Product Change Notification / SYST-23UFEG663

ERRATA - KSZ9131RNX Silicon Errata and Data Sheet Clarification

Silicon Errata and Data Sheet Clarification

FIGURE 1: TOP MARKING DATE CODE INDICATION

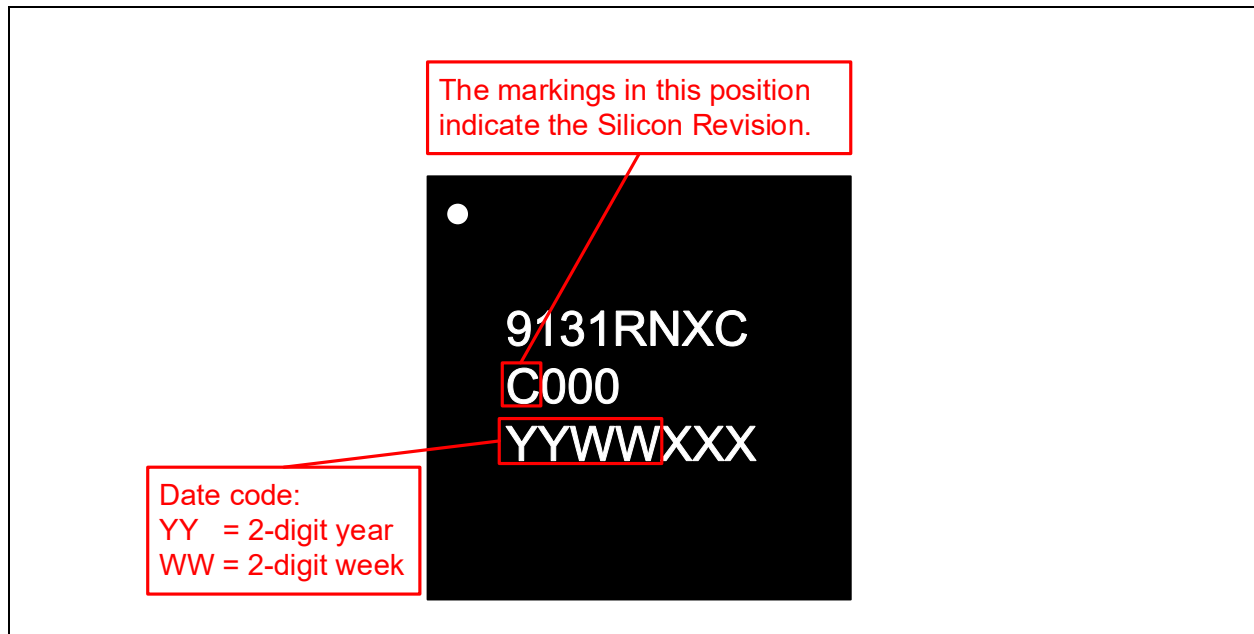
Description of Change: 1) Added Module 3: 1000M EEE needs 100M Advertisement Enabled 2) Changed silicon revision letter from "C0" to "C."
